HISTORIC AND DESIGN REVIEW COMMISSION

June 03, 2020

HDRC CASE NO: 2020-208
ADDRESS: 130 CAMARGO
LEGAL DESCRIPTION: NCB 923 BLK 4 LOT 5 & W 27.8FT OF 6
ZONING: RM-4,H
CITY COUNCIL DIST.: 1
DISTRICT: Lavaca Historic District
APPLICANT: Robert Alvarado/South Antonio Builders
OWNER: Kathryn Ruckman/BEANVILLE BUNGALOWS LLC
TYPE OF WORK: Exterior alterations, site modifications
APPLICATION RECEIVED: May 15, 2020
60-DAY REVIEW: Not applicable due to City Council Emergency Orders
CASE MANAGER: Stephanie Phillips

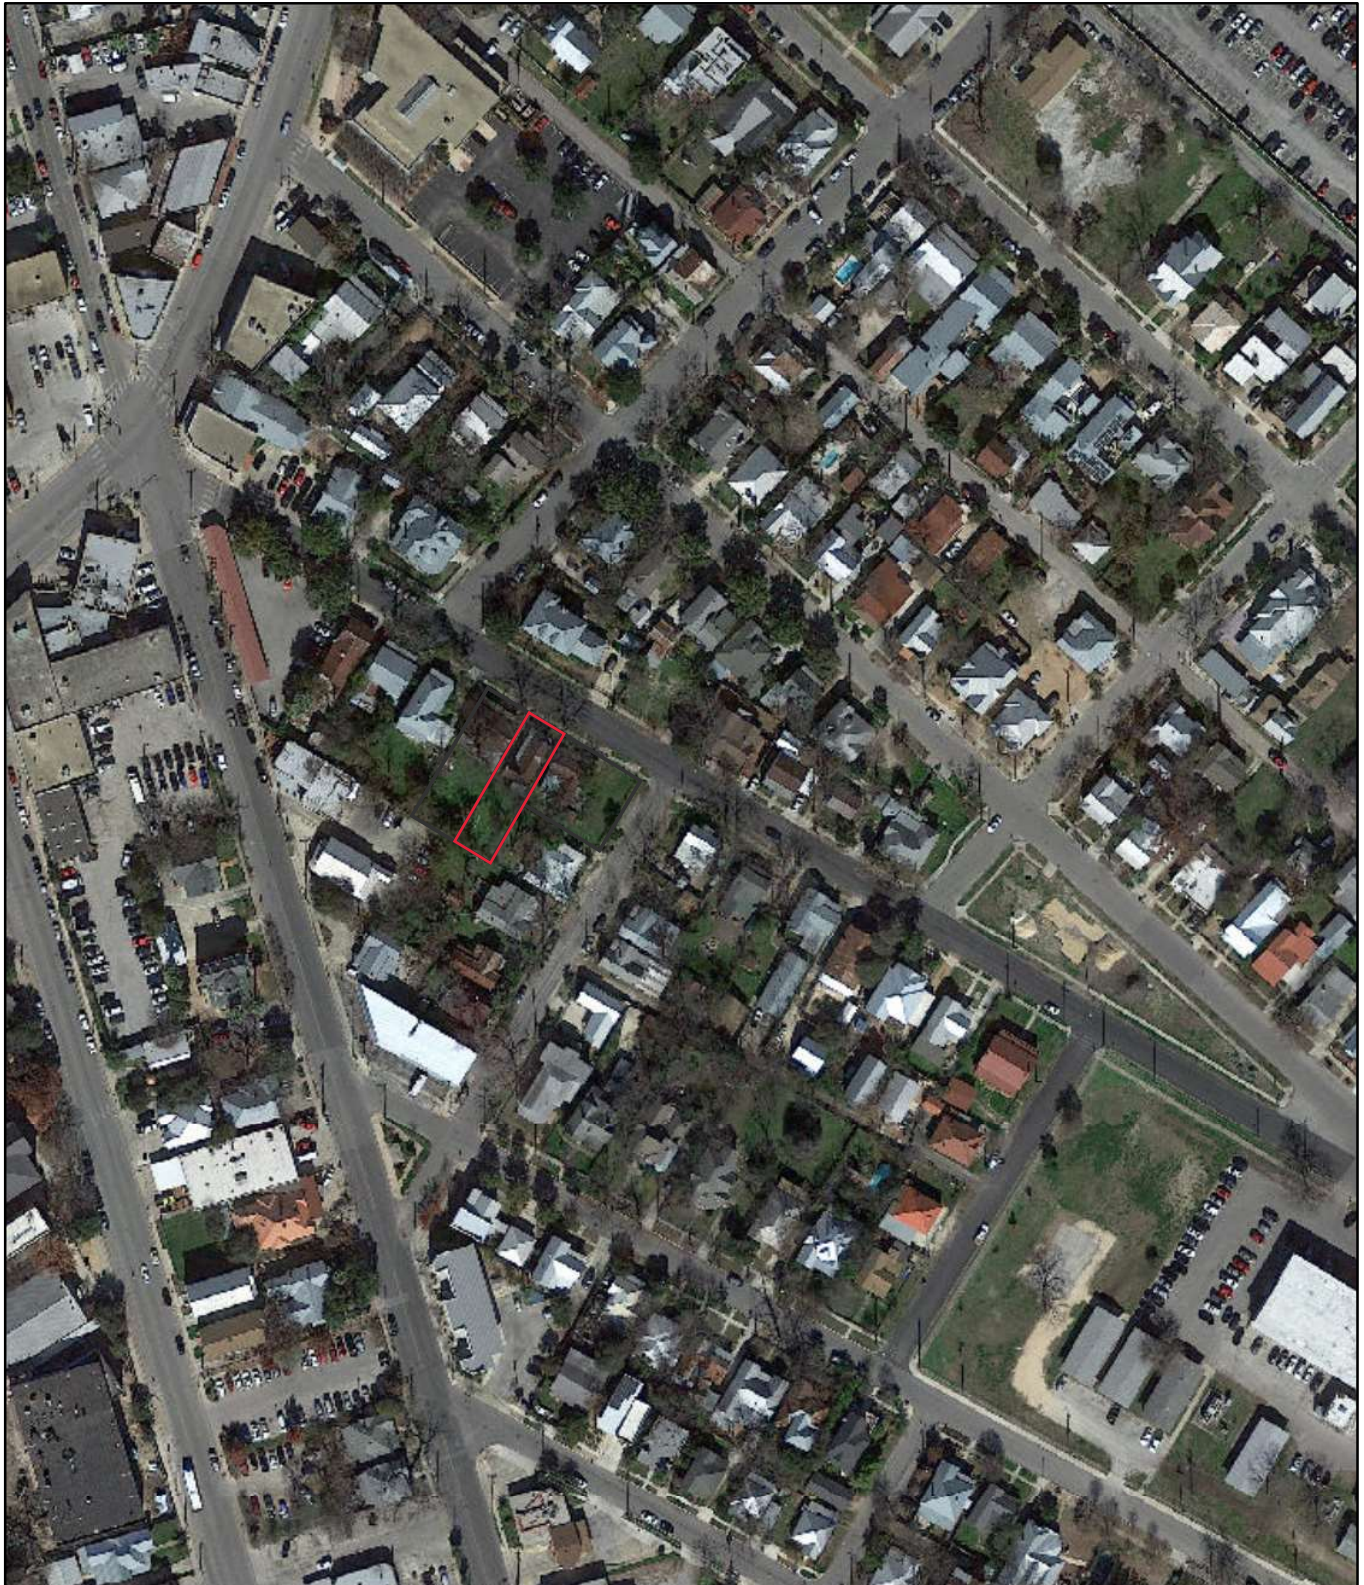
- a. The primary structure located at 130 Camargo is a 1-story single family structure constructed circa 1890 in the Folk Victorian style. The structure features a side gable configuration, full-width front porch, board and batten siding, and metal roof. The structure is contributing to the Lavaca Historic District and was recently relocated to its current siting from 12 feet to the east.

126, 130, & 132 CAMARGO - PROPOSED FENCE PLAN

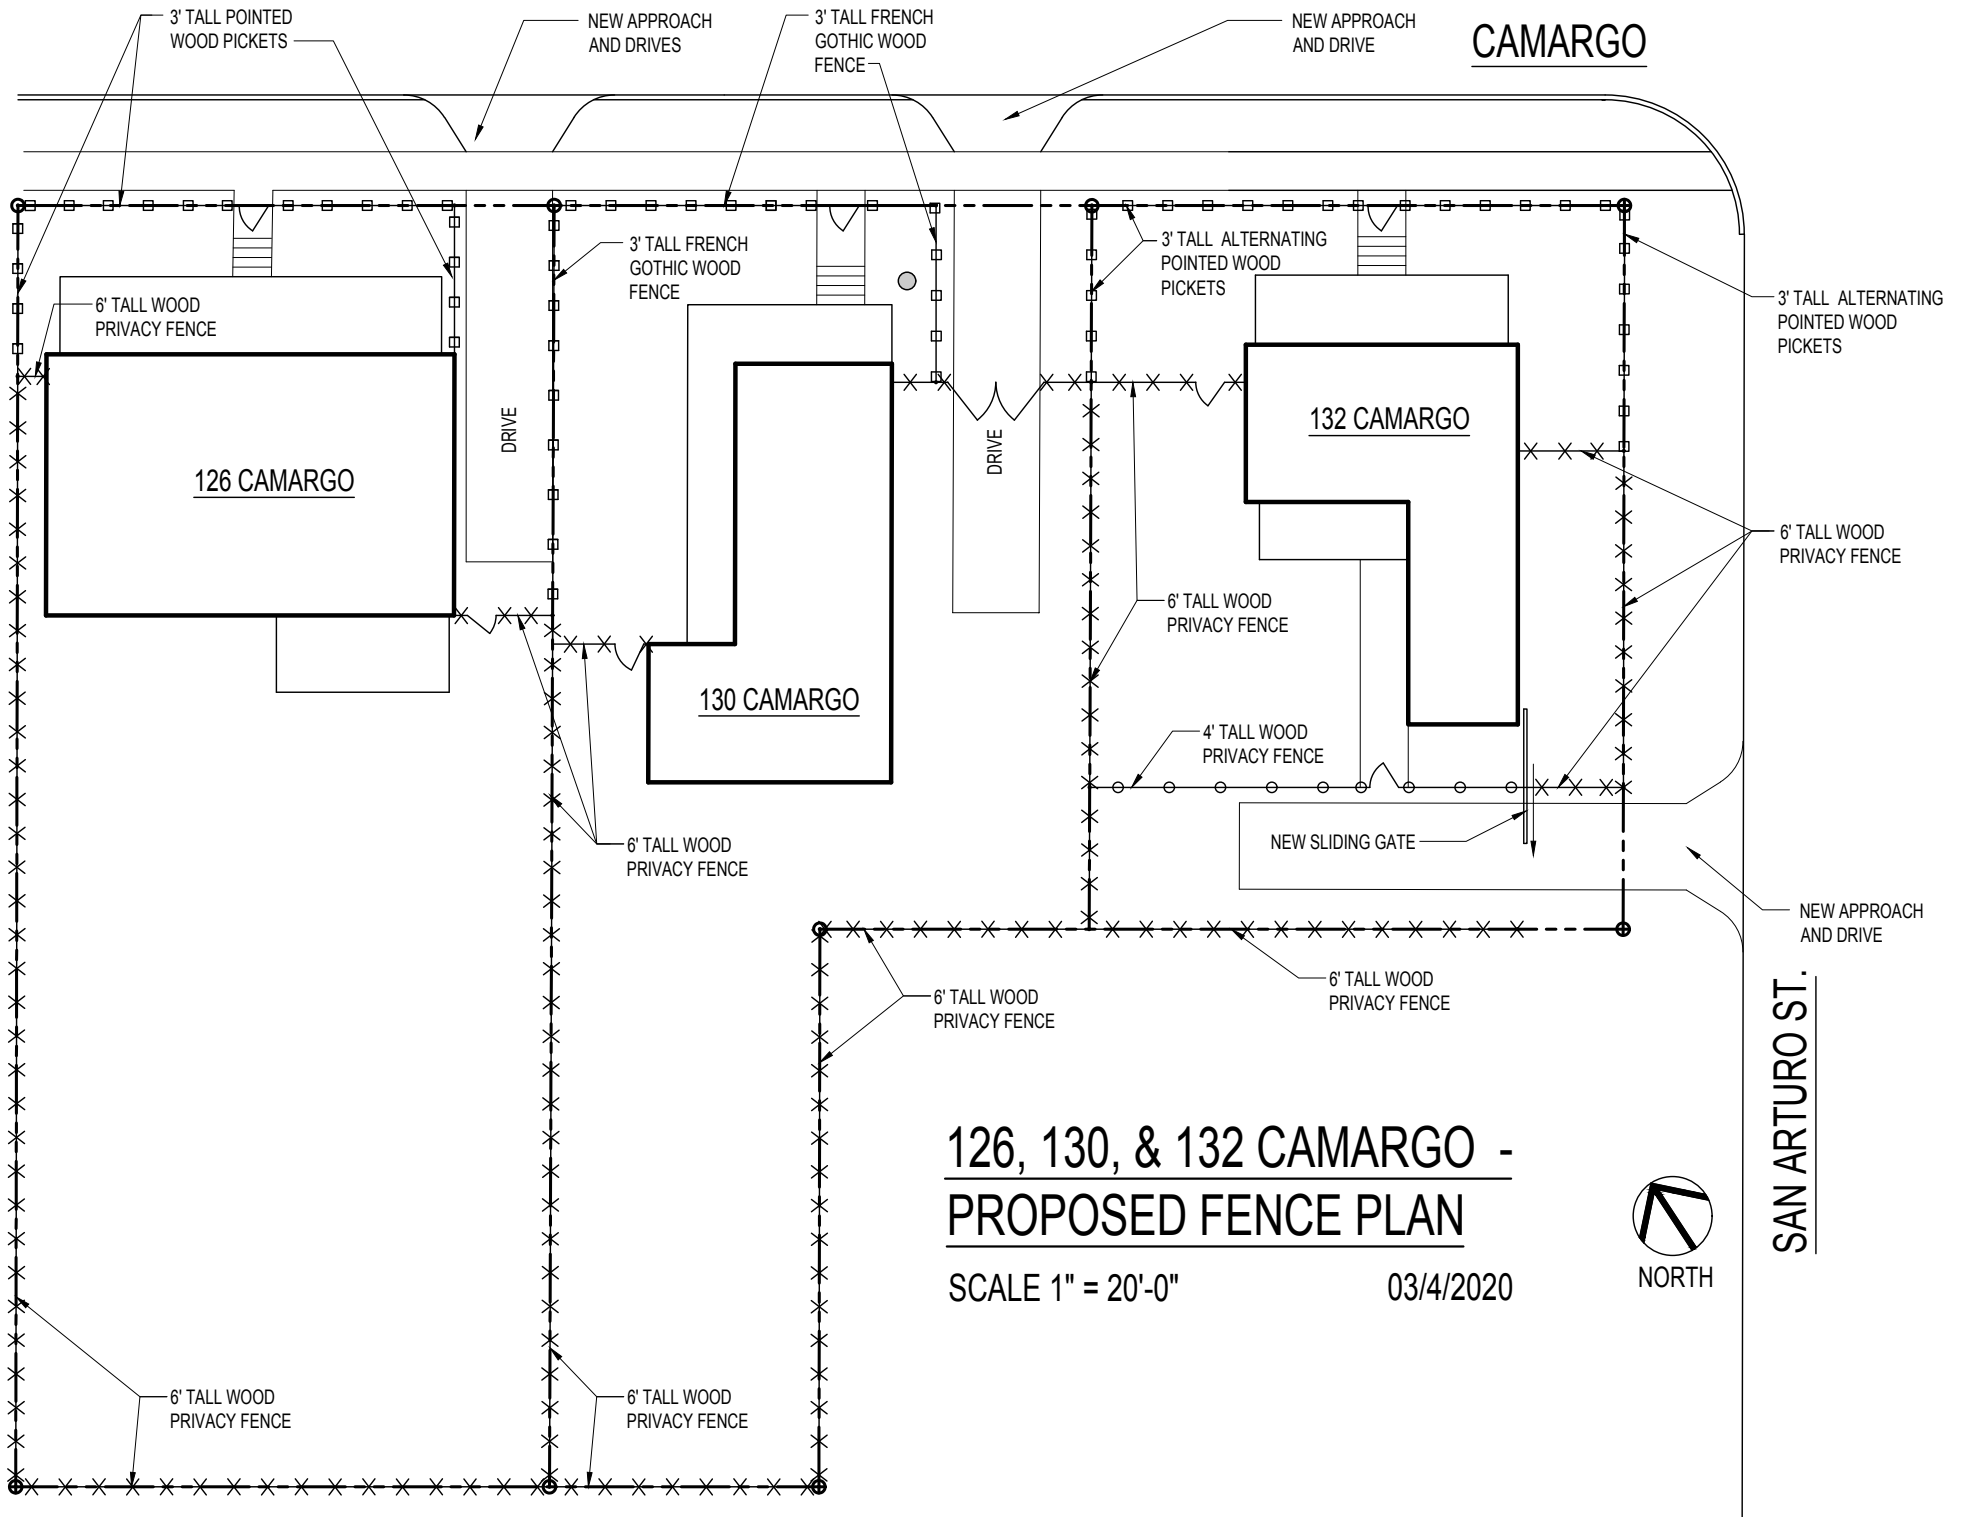
- e. **WALKWAY** – The applicant has proposed to install a poured concrete walkway and curb from the street leading up to the new proposed staircase. According to the Historic Design Guidelines, the historic alignment, configuration, and width of sidewalks and walkways should be followed. Staff finds the proposal consistent with the Guidelines.

- f. **DRIVEWAY** – The applicant has proposed to install a new rear driveway. The driveway will measure 10 feet in width and will be constructed decomposed granite with brick lining the perimeter. The apron will be poured concrete. According to the Guidelines, a similar driveway configuration—materials, width, and design—to that historically found on the site should be incorporated. Historic driveways are typically no wider than 10 feet. Pervious paving surfaces may be considered where replacement is necessary to increase stormwater infiltration. Staff generally finds the proposal appropriate, but requires a material specification and dimension for the brick.

- iv. That the concrete walkway be no wider than 4 feet.
- v. That the driveway be no wider than 10 feet and that the approach flare to no wider than 12 feet at its widest point. The applicant is required to submit a material specification and dimension for the brick. Staff finds a brick that closely matches the color of the decomposed granite to be most appropriate.

1 130 CAMARGO - NORTH ELEVATION
SCALE : 1/8" = 1'-0"

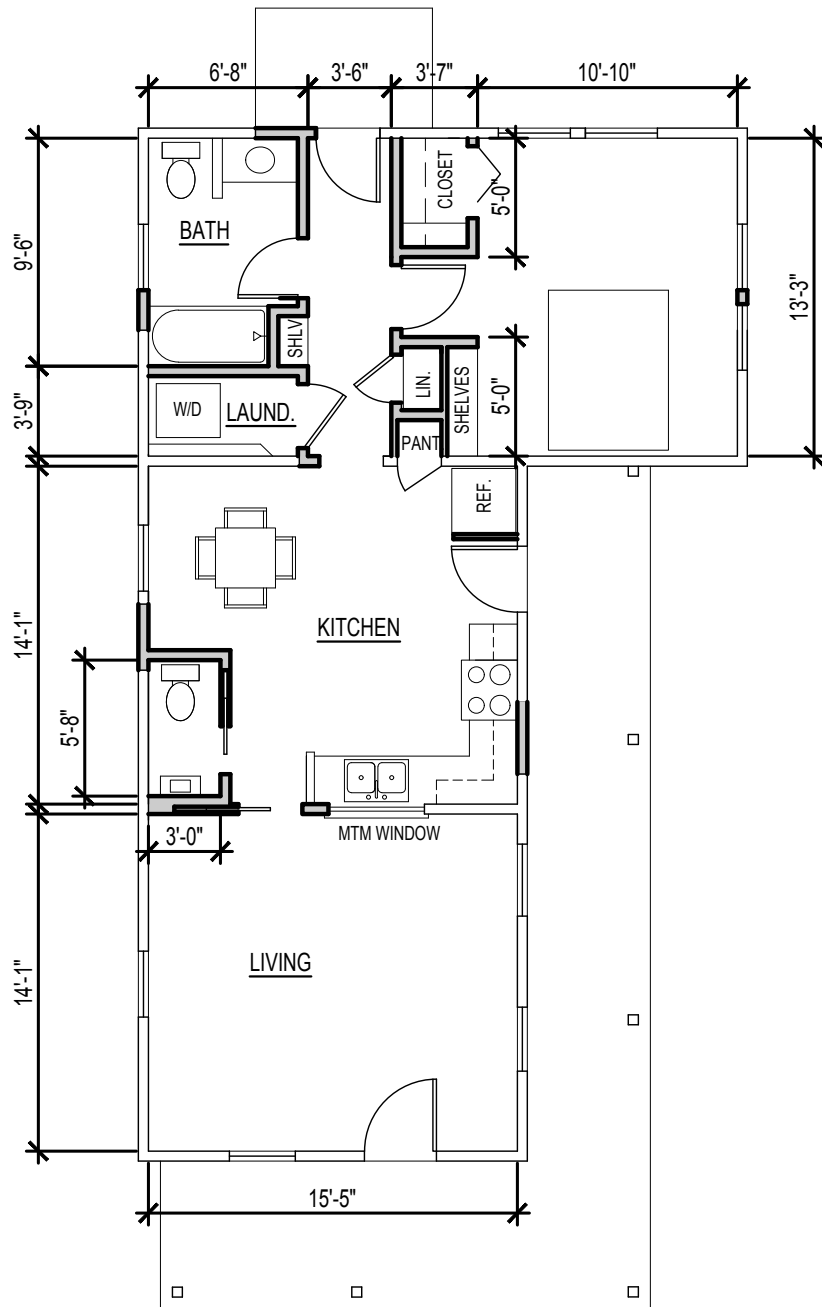
- b. **PORCH** - The applicant has proposed to rebuild the front and side porch to historic configuration, including columns, rails, balustrade, and brackets. The porch will feature square columns with a simple traditional base and capital and the proposed railing will feature turned balustrades, which are common of the Folk Victorian style. According to the Historic Design Guidelines, porches, balconies, porte-cocheres, and related elements, such as ceilings, floors, and columns, should be replaced in-kind when such features are deteriorated beyond repair or missing. When in-kind replacement is not feasible, the design should be compatible in scale, massing, and detail while materials should match in color, texture, dimensions, and finish. Staff finds the proposal generally consistent with the Guidelines.

- d. **FENESTRATION** - The applicant has proposed to remove one of two existing side doors and replace with a wood window to match the existing on the historic structure. The primary front door facing Camargo will remain. Staff finds this modification appropriate.

- ii. That the columns be no wider than 6x6” and feature a traditional capital and base and chamfered corners.
- iii. That the applicant provides a measured detail drawing of the proposed porch gingerbreading, or a photo if reclaimed, prior to the issuance of a Certificate of Appropriateness.
